Safe System Audit - Proposed Subdivision at Arawa Road Pongakawa

Quality Assurance Information

This audit is a concept stage safe system audit of the transport design associated with a possible new subdivision at Arawa Road in Pongakawa.

Figure 3.2 Scheme layout (longer deceleration lane)

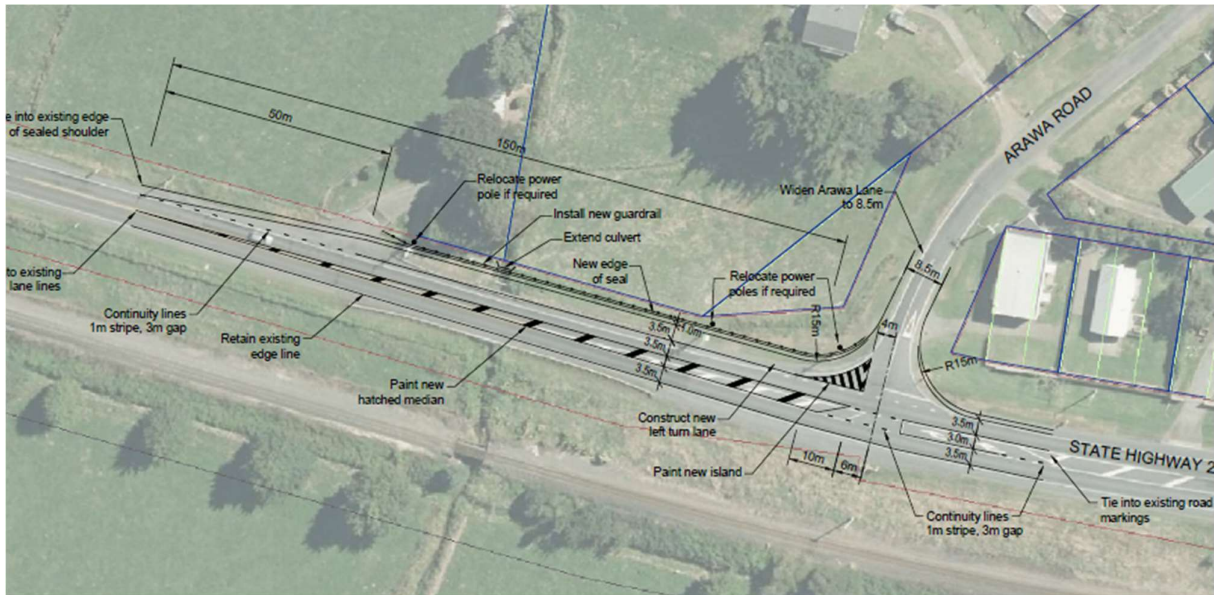
Likelihood of crashes remains the same across both situations with no real changes affecting most crash types. For intersection crashes, the likelihood of rear-end type is reduced by the proposed channelised left-turn, but this is offset by the increase in risk due to the potential dynamic visibility obstruction by vehicles in the left-turn lane for higher severity side impact crashes.

Figure 5.2 – Left turning vehicle creating obstruction to sightlines for emerging driver

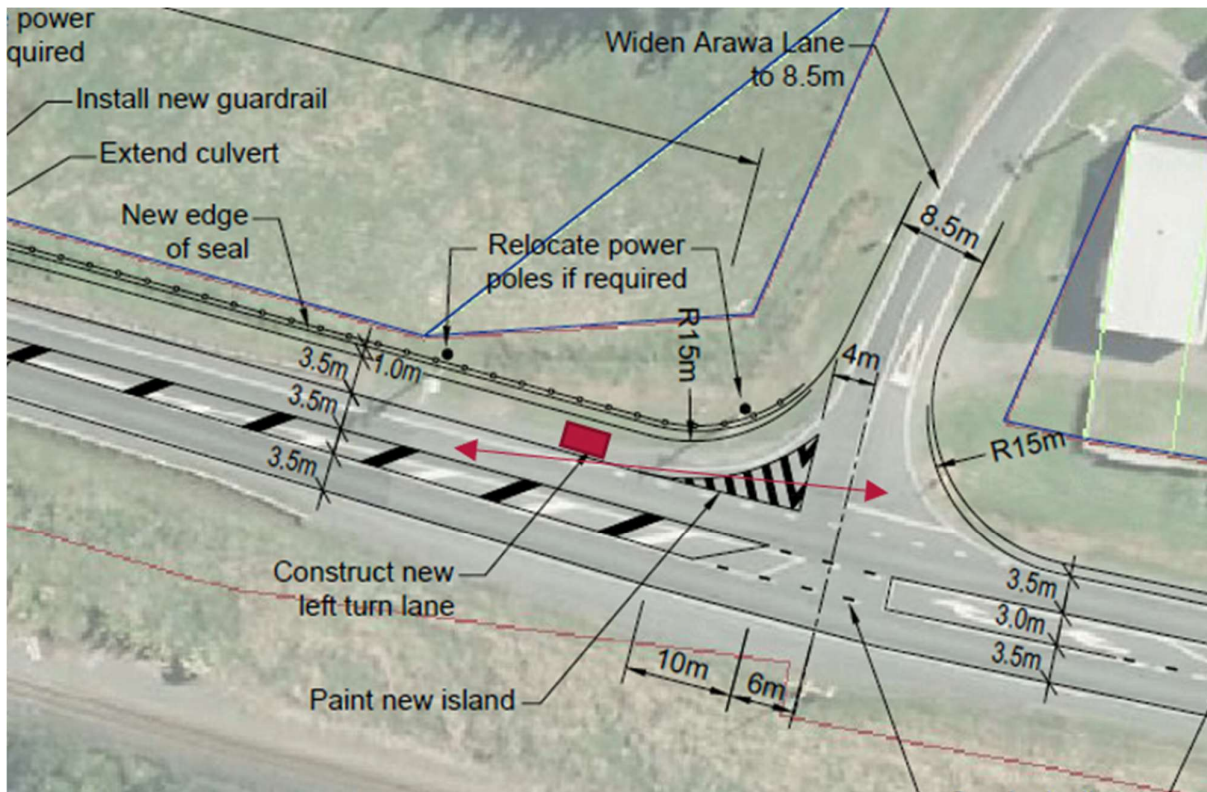
There is no separation between the proposed channelised left-turn lane and the through lane on the eastbound approach to Arawa Road. Left-turning vehicles could create a dynamic visibility obstruction for drivers exiting Arawa Road. This increases the risk of side impact crashes involving vehicles emerging from Arawa Road in conflict with eastbound through traffic.

Vehicle flows into and out of Arawa Road will remain relatively low and are expected to be tidal (movement out in the morning peak and in in the evening peak), which reduces the risk that a vehicle will be turning in at the same time as another is emerging. There is unlikely to be a queue of vehicles turning left or a high number of heavy vehicles which reduces the level of sight-line obstruction. Therefore, the frequency of this type of crash is considered to be very unlikely.

The operating speeds on SH2 significantly exceed the safe system threshold for side-impact so there would be a high probability of fatal injuries for any crash occurring.

Consider offsetting the channelised left-turn treatment so that left-turning vehicles do not obstruct visibility for drivers emerging from Arawa Road.

If the left-turn lane cannot be offset for the full length, consider:

- providing a Short Turn Lane [AUL(S)] in accordance with Austroads Guide to Road Design, Part 4A section 8.2.2 with additional offset to mitigate the visibility obstruction. Although this will increase the risk of rear-end crashes they have a lower potential severity than side impact crashes
- reducing the width of the left turn lane to 3.0m with a 1.0m shoulder to provide additional 0.5m offset between the through lane and the left-turn lane.

Whether a short or full auxiliary lane is provided, it should be designed for the existing operating speed rather than the reduced speed limit, unless a speed limit reduction is confirmed, and measures are put in place to reduce operating speeds.
